**Submission with regard to Amended Plans submitted on 12 April 2023 - DA2022/0596  
Construction of a mixed use development comprising retail and co-living housing over  
part basement parking  
29-37 Dobroyd Road, Balgowlah Heights, NSW**

This submission is prepared in response to Amended Plans dated 12 April 2023 on Council's DA tracker.

**Figure 2 – Ground Floor residential units as it presents to Commerce Lane**

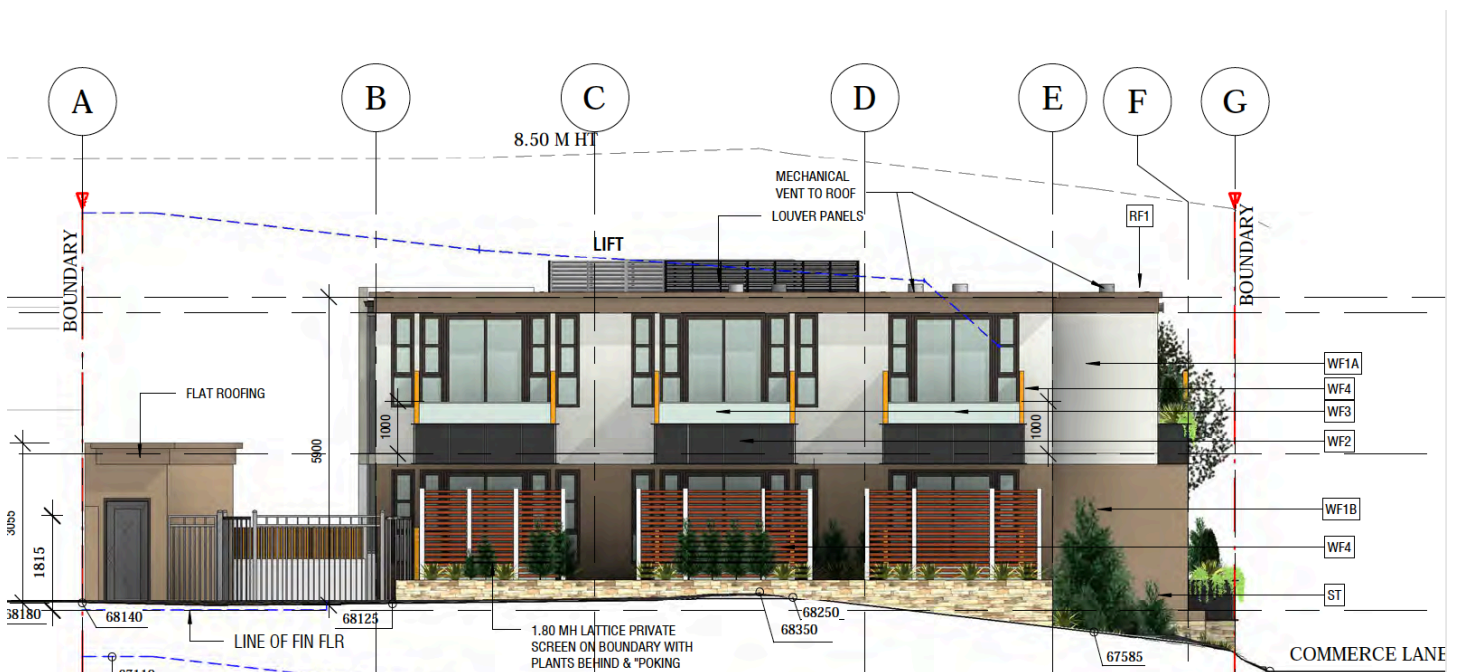
The proposed development, as also detailed in the objection letter dated 8<sup>th</sup> June 2022, does not comply with Part 3, Section 69 (1), (e) of the Housing SEPP as the ground floor level to Commerce Lane is proposed to be used for residential purposes.

**Recommendation:** The proposed development should be refused as it does not comply with the Housing SEPP.

**Figure 3 – Proposed retention and planting in existing planter boxes on the boundary of 31 Dobroyd Road (outside of the subject site area).**

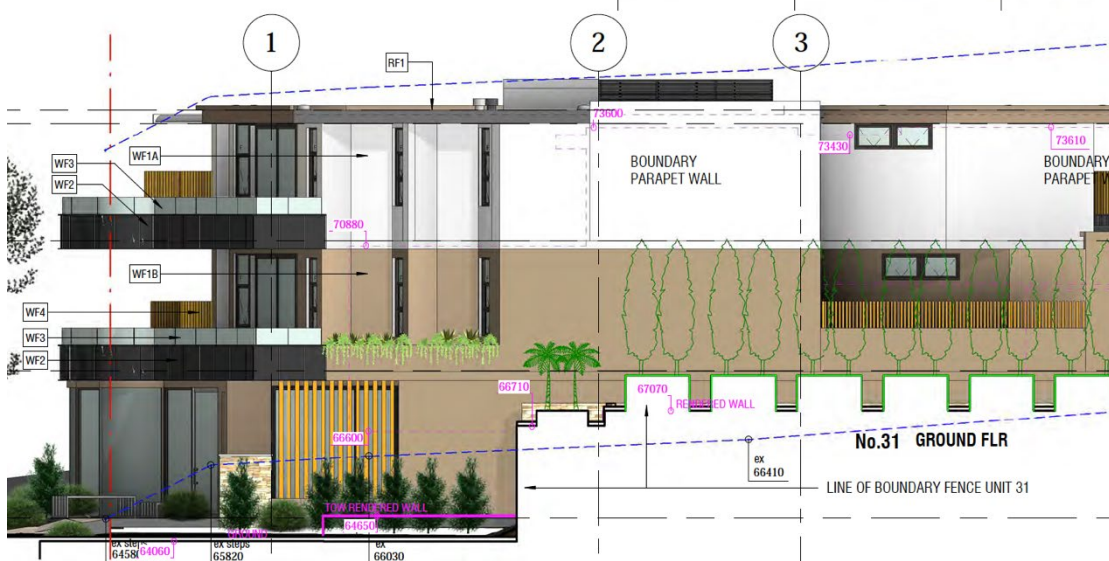
Importantly, the proposed planting of 2 trees per planter to grow up to 3 metres in height would substantially increase the already detrimental impact on my clients in terms of loss of sunlight, overbearing impacts and loss of outlook brought about by the inadequate separation distances proposed.

- Planter boxes are existing
- Planter boxes are on neighbouring land – outside of applicant’s control
- 3 metre high evergreen trees within 0.8 -4m max of my client’s property would exacerbate the impacts to arise
- Minor 50mm setback is proposed to the western boundary. A 5-centimetre setback is unacceptable.
- Separation distances have not been annotated on the amended plans.

**Recommendation:** Should the subject DA not be refused, despite the outstanding objections cited, the proposed development should be setback significantly, in accordance with DCP Control 4.2.8.2 (ii) given that a nil setback [or 5cm which is tantamount to a nil setback] is undesirable in terms of amenity of adjoining land or as specified under the building separation distances in the ADG, should the proposed development commence under the Housing SEPP.

It is also recommended that planting or adequate privacy mitigation measures be proposed within the site and not rely on planting outside of the site, which can't be conditioned.
